Submission to Sydney Olympic Park Master Plan 2030 (2016 Review)

On behalf of The GPT Group

15 November 2016

Figure 3: MP Review – Proposed Urban Structure Road Connections - Fragmented, small lots within GPT's site

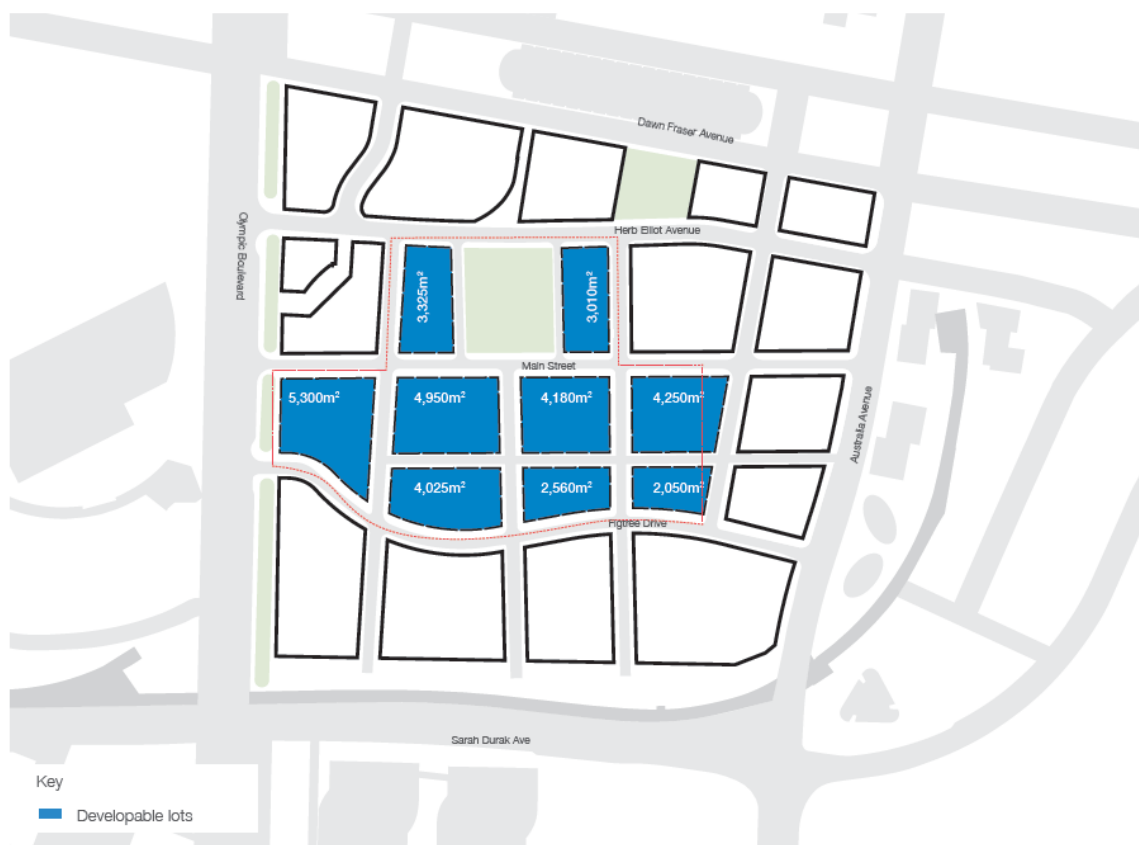
Figure 3 illustrates the indicative lot sizes that will result from the proposed vehicle connections. The lots are all under 5,000m², with the exception of the lot fronting Olympic Boulevard, which is 5,300m². Some of the lots are particularly small at around 2,000m²-2,500m².

Figure 4 Spatial Requirements for Typical Retail Layouts

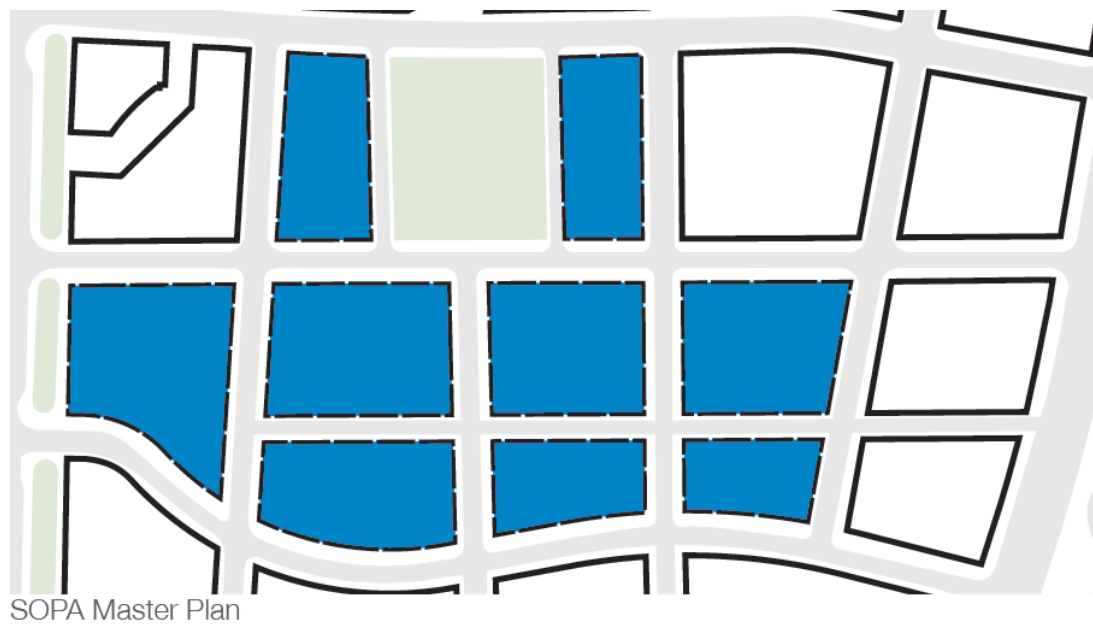
A scaled comparison of the spatial requirements of these necessary retail anchors to GPT’s site is illustrated in Figure 4. The average size of a full line supermarket (excluding loading and ancillary specialities) is around 4,200m², a discount department store is 6,000m², a cinema is 7,000m² and a department store is around 8,000m² to 2,000m². Figure 4 clearly demonstrates that the lot sizes resulting from the proposed vehicle connections are too small to accommodate these anchors.

Figure 5: Spatial Requirements for Typical Retail Layouts – Anchor with speciality to edge

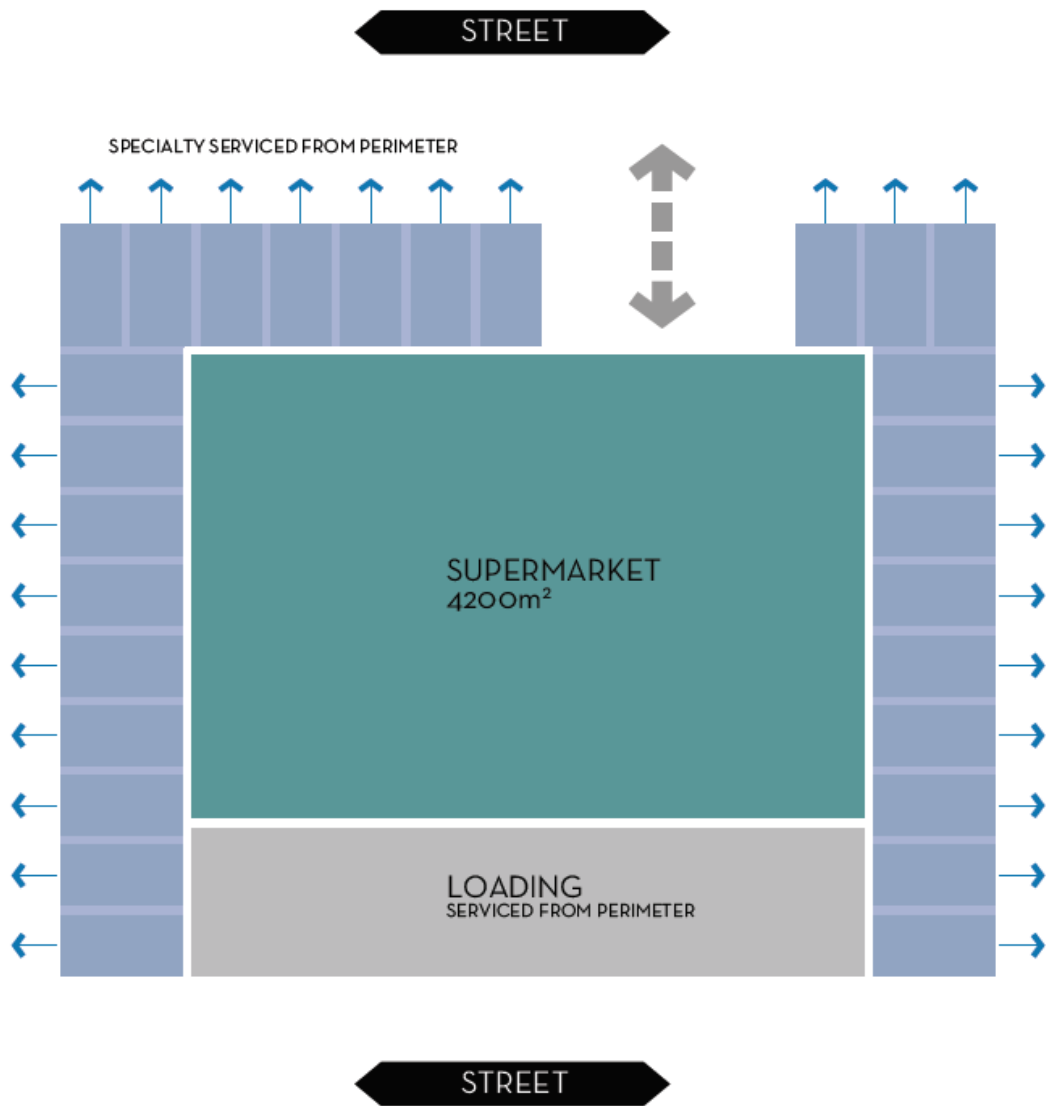
This is reinforced further in Figure 5, which shows spatial requirements of supermarket (including servicing) with ancillary activation along the streets in the form of speciality shops, cannot be achieved on the largest lots currently proposed.

Figure 9: Extract of Figure 5.6 Central Precinct Site Floor Spoe Ratio Plan (Source MP Review)

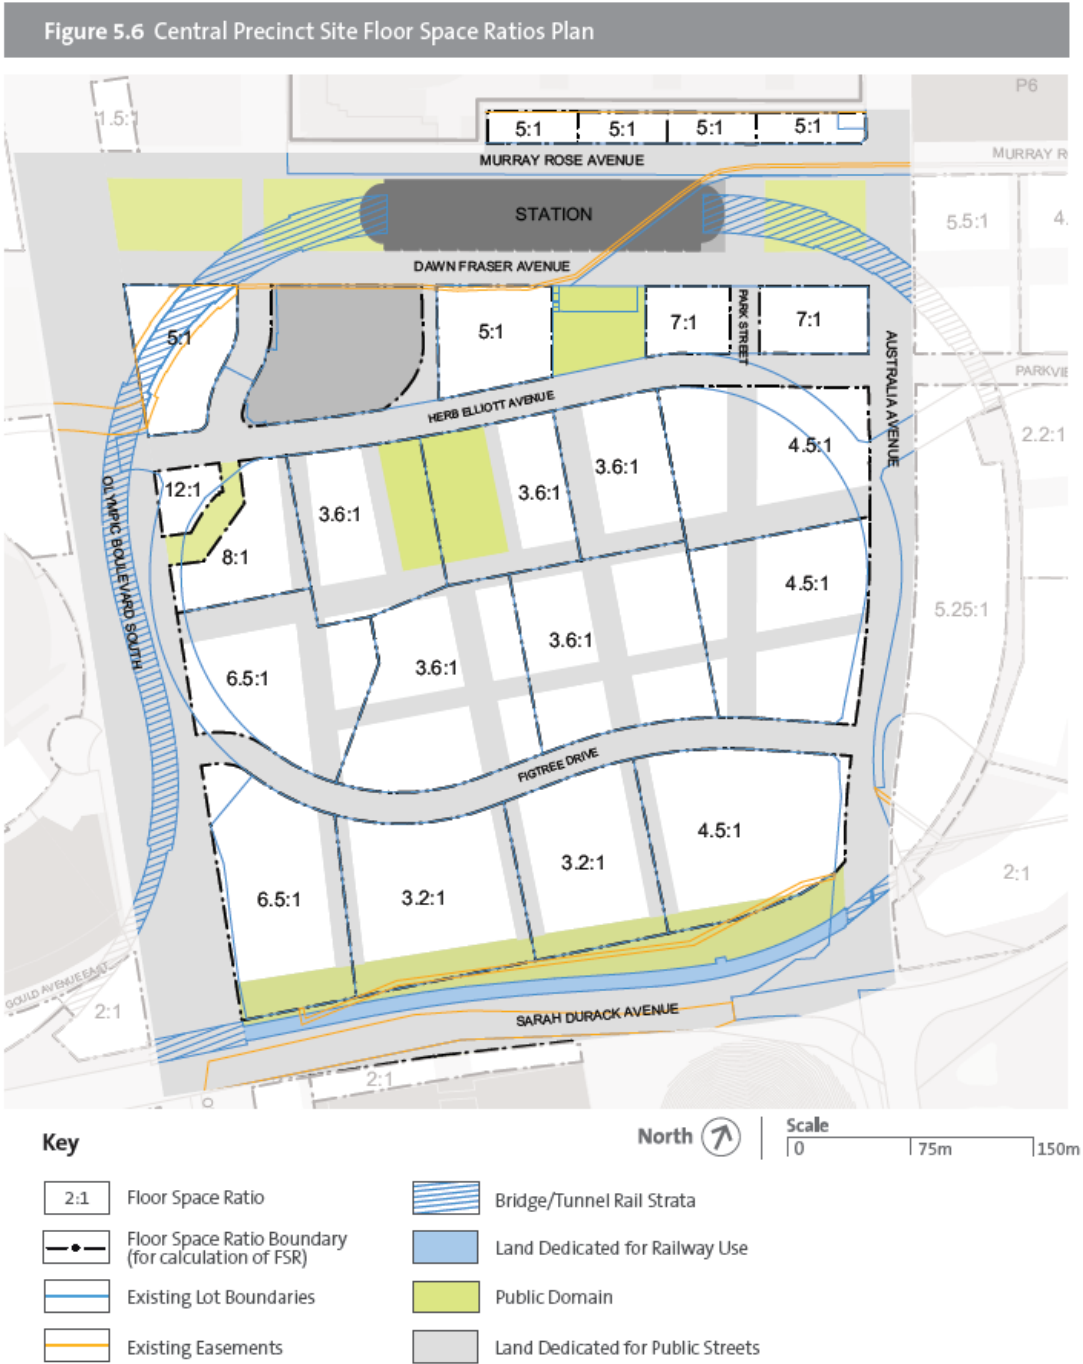
The fragmentation of these lots by the proposed park also impacts on the ability to realise the eight (8) storey commercial/retail buildings that are envisaged for these sites under the MP Review. Each these sites have an FSR of 3.6:1, which utilises the FSR from the park (refer to Figure 9).

Furthermore, the allocation of FSR as shown in Central Precinct Site FSR Plan is unnecessary. The map includes the same FSR as contained in the SEPP, but allocates the FSR over irregular parcels. The maps should be deleted as it does not provide any clarity as to the FSRs that could be achieved on the development lots.

- Delete Figure 5.6 Central Precinct Site Floor Space Ratio plan from the Master Plan.
- Review FSR's in the SEPP.

Figure 10: Extract of Figure 5.6 Massing analysis illustrating impact of park on FSR

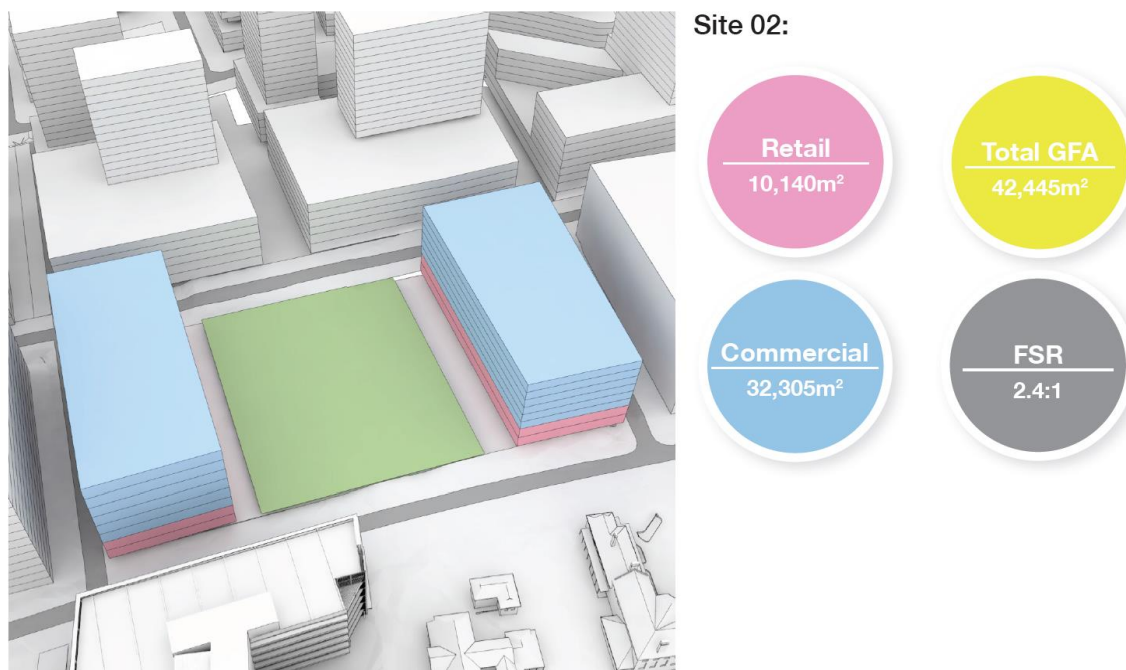
As illustrated in the massing analysis at Figure 10, this potential FSR cannot be realised on sites of around 3,000m². Instead the FSR will be limited to around 2.4:1, which coupled with the limitation on retail typologies, has a significant impact on the delivery of the envisaged retail and commercial targets and viability of the development generally.

Figure 6: MP Review – Proposed Urban Park – GPT's site Central Precinct

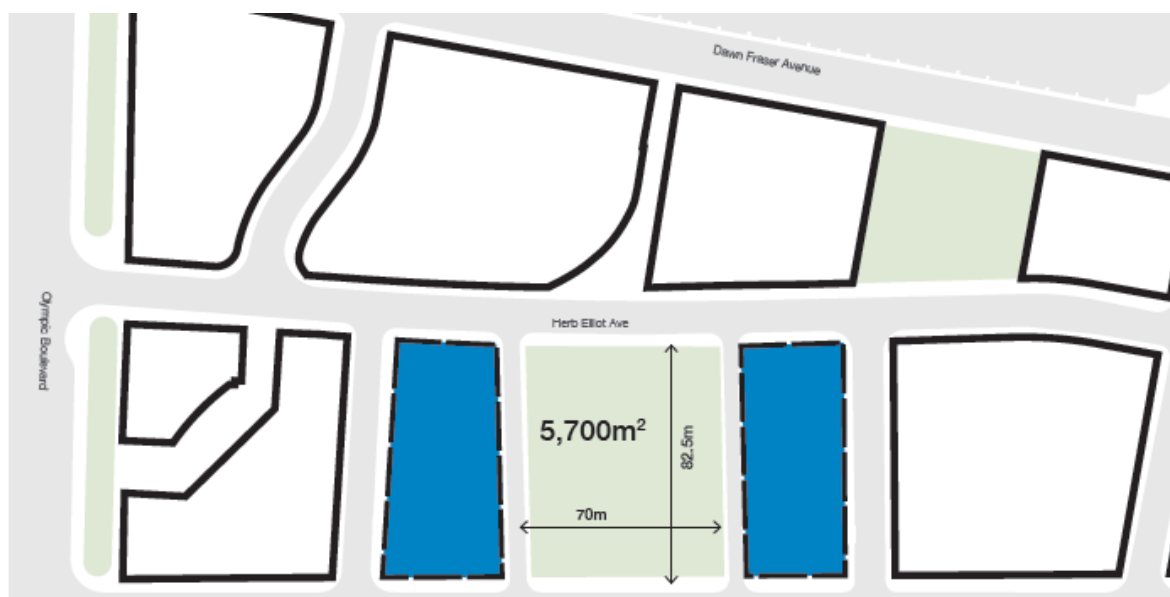
As illustrated in Figure 11, at 70m wide and 80m long, and with an area of around 5,700m², the proposed park is a large, expansive space that will be difficult to activate with surrounding land uses. The fact that the space is surround by roads exacerbates the fragmentation and opportunities for activation.

Figure 4: Central Precinct Land Uses Plan

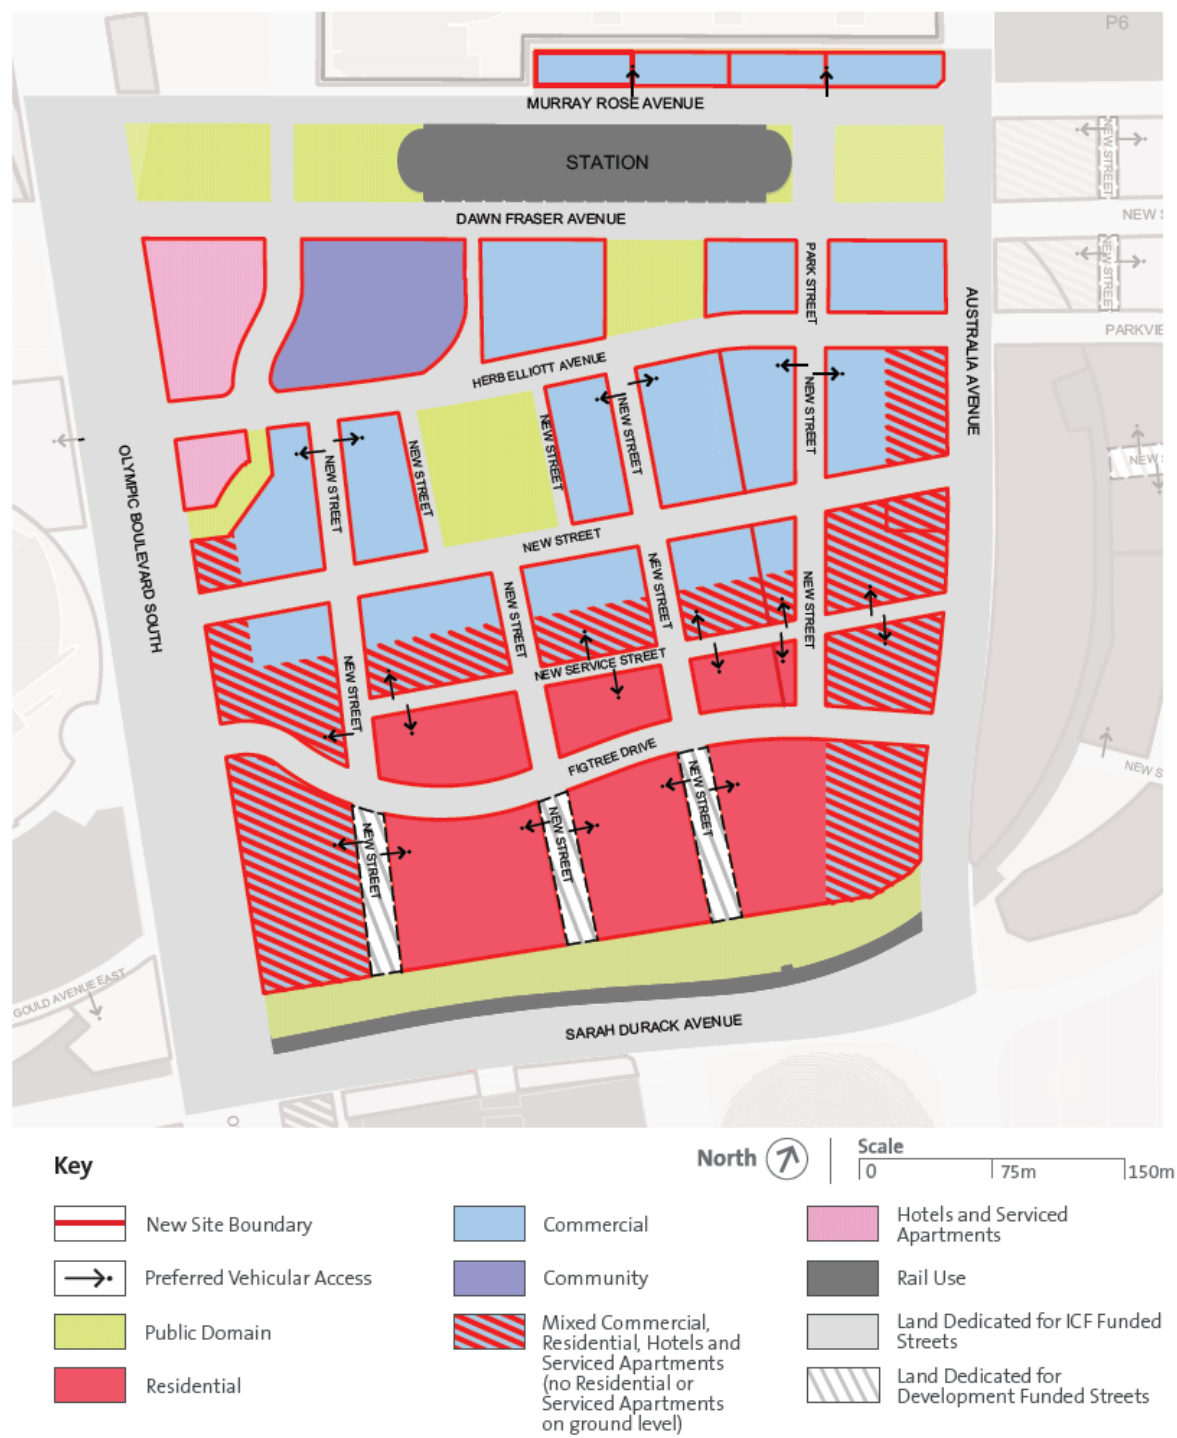
The MP Review proposes an east-west mixed use precinct extending through the centre of the site that is flanked by a commercial precinct to the north and a service road and residential zone to the south (refer to Figure 14).

Figure 16: Constrained tower placement within the existing mixed use precinct

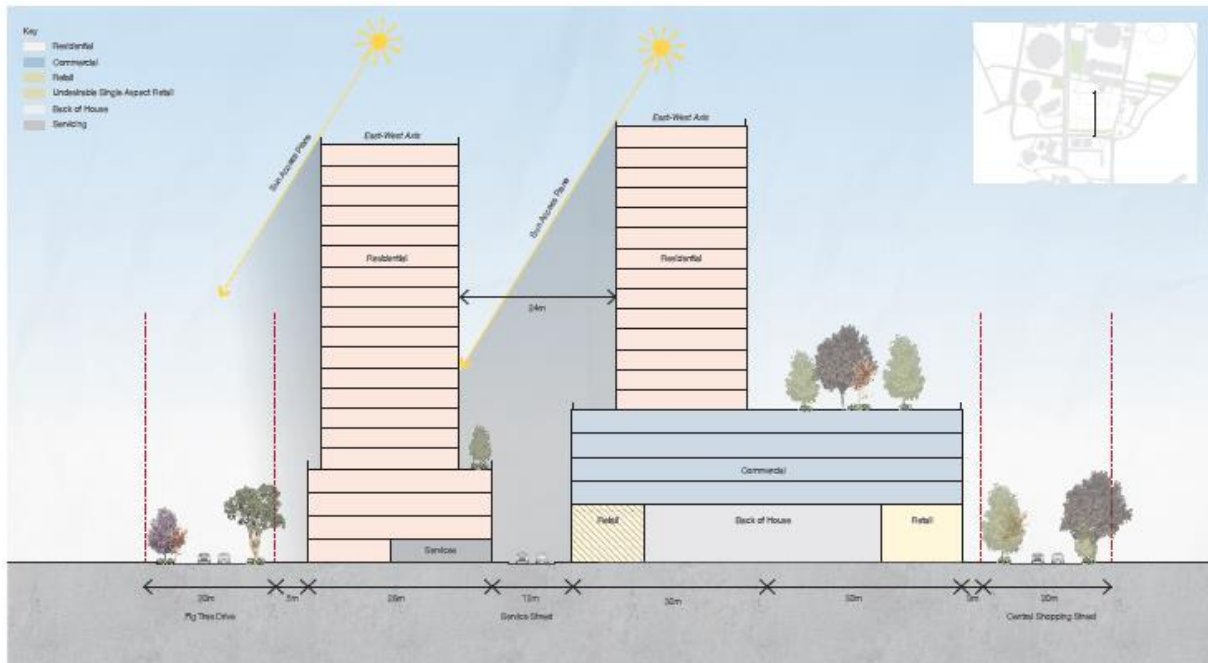
As a result of the abutting commercial precinct, the placement of the residential towers is restricted to the 30m mixed use precinct, as residential uses are not permitted in the commercial zone. This pushes the towers further south. In addition, the narrow depth of the mixed uses precinct forces the orientation of the towers to be east-west. As illustrated in Figure 16, these two factors create overshadowing to the buildings in the adjacent residential zone and impacts on the ability to satisfy the SEPP 65 ADG solar design criteria.

Figure 17: More flexible tower placement within an extended mixed use precinct

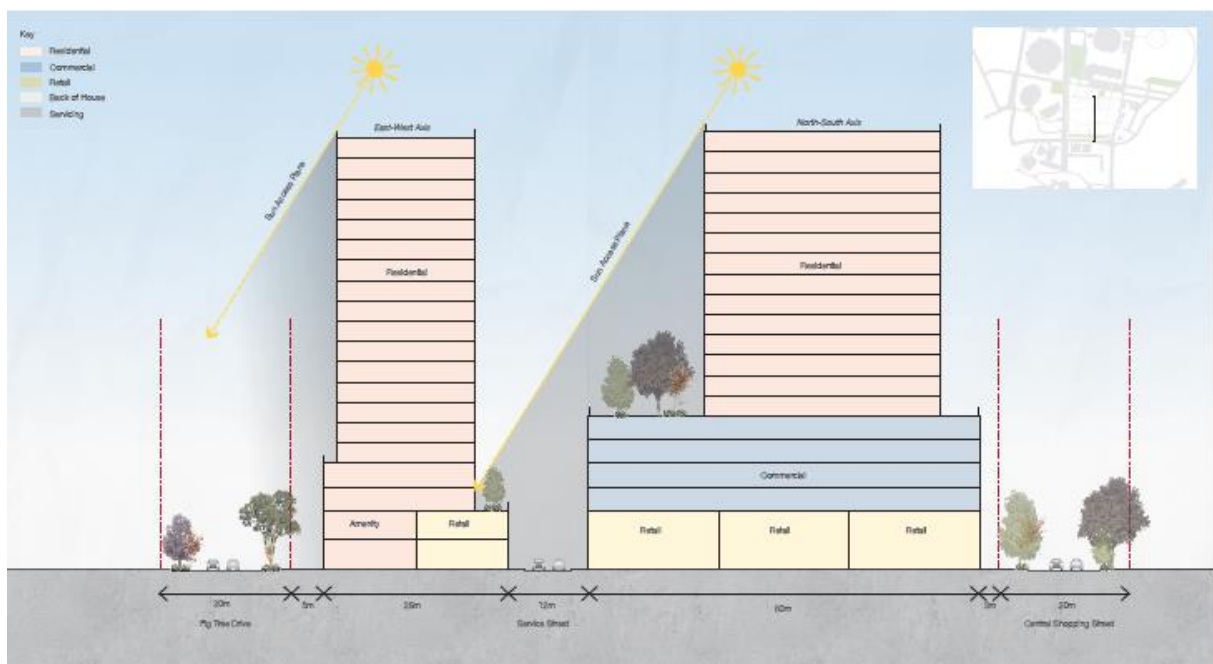
A larger mixed use precinct provides more flexibility in relation to the placement and orientation of towers north-south, which reduces the extent of overshadowing of buildings as shown in Figure 17.

Figure 19: Provide a greater variation in tower heights across the precinct (east-west)

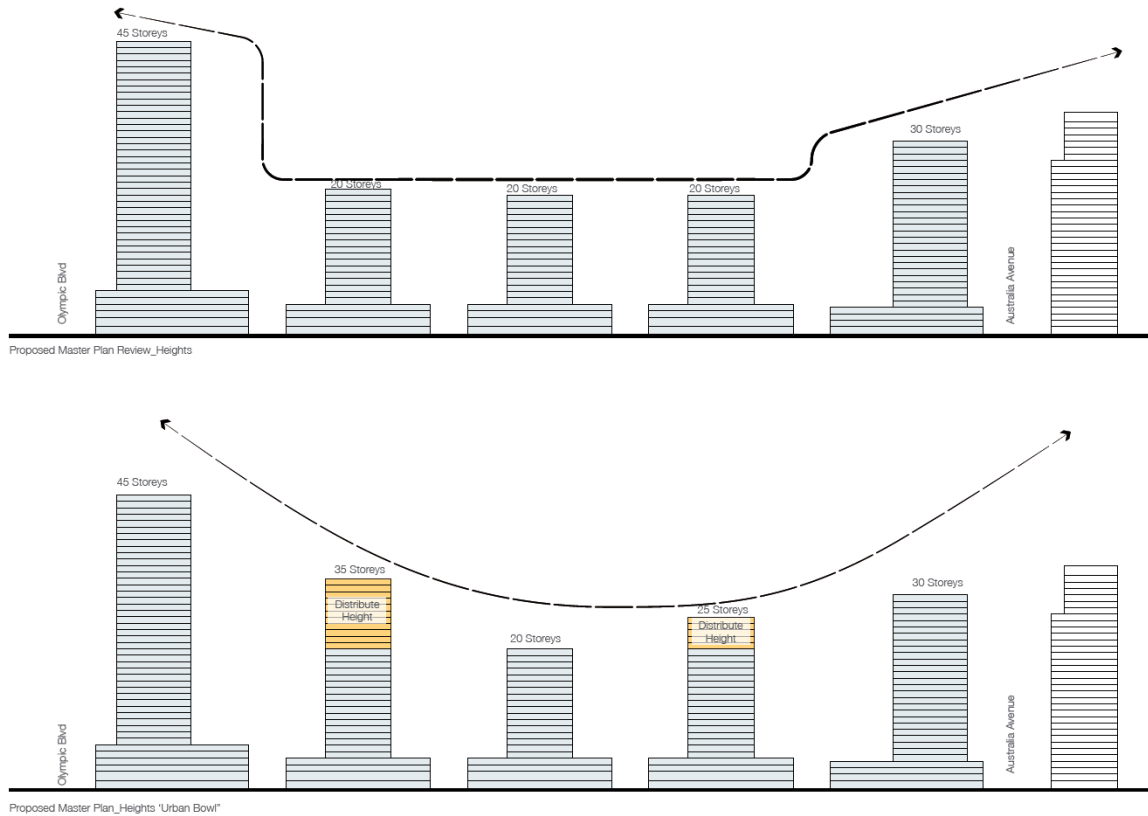
While the building heights have been increased across the Central Precinct, the heights are uniform, particularly the 20 storey tower heights within the centre, which are located between the 45 storey heights on Olympic Boulevard and 30 storey heights on Australia Avenue.

A greater variety in the tower heights located between the two perimeter towers heights would provide a better urban design outcome by reinforcing the concept of the 'urban bowl'. As illustrated in Figure 19, 20 storey heights should be increased to 25 storeys and 35 storeys, with 20 storey heights maintained in the centre.

- Amend the building heights maps in section 5.2 of the Master Plan to indicate 25 and 35 storey buildings as illustrated in Figure 20.
- Amend the SEPP Building Height Map as illustrated in Figure 21 to increase the buildings heights from 74m to 90m and 102m to allow for the 25 storey and 35 storey height variation in the centre of the precinct.
